RE: 2024 Annual River Crossing Report

Further to your December 24, 2025 letter, below are the clarifications requested related to the 2024 Annual River Crossing Report.

Figure 1: High Risk River Crossing AMP – Section 4.3.3

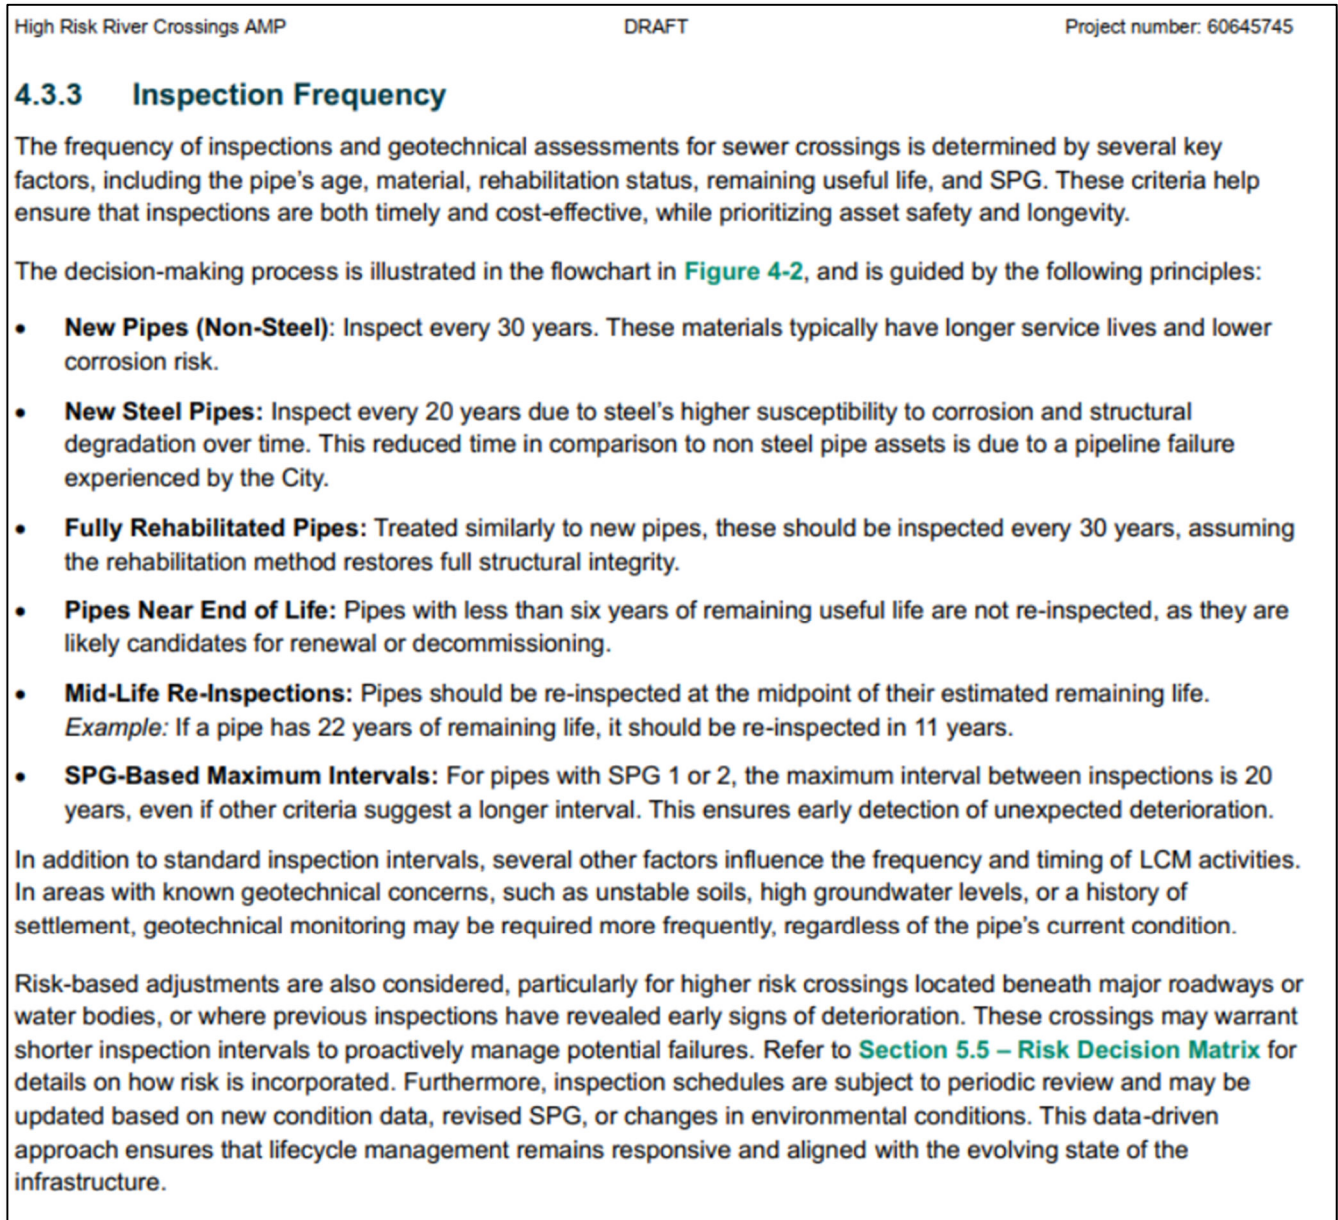
- ***How inspection frequencies are determined and why they deviate from the approved 2017 Technical Memorandum.***

In 2025, the City commissioned a comprehensive AMP for the River Crossing asset class. Section 4.3.3 from the draft AMP which outlines how inspection frequencies are determined is provided in the appendix – Figure 1. As noted above, the AMP will be forwarded to your office shortly.

The 2017 Technical Memo differs as it was related to a specific project's requirements rather than a comprehensive asset management strategy. The 2017 memo outlined a plan to meet licensing requirements for upgrading the Northeast Interceptor and wasn't intended to address the overall inventory of river crossing assets. The frequency table, while relevant in 2017, cited information from 2001. This information came before the City developed a strategy for classifying and monitoring river crossings. Since 2017, the City has gained more knowledge about deterioration and uses advanced analytics and tools to assess the condition and quantify failure risk of the river crossing assets.
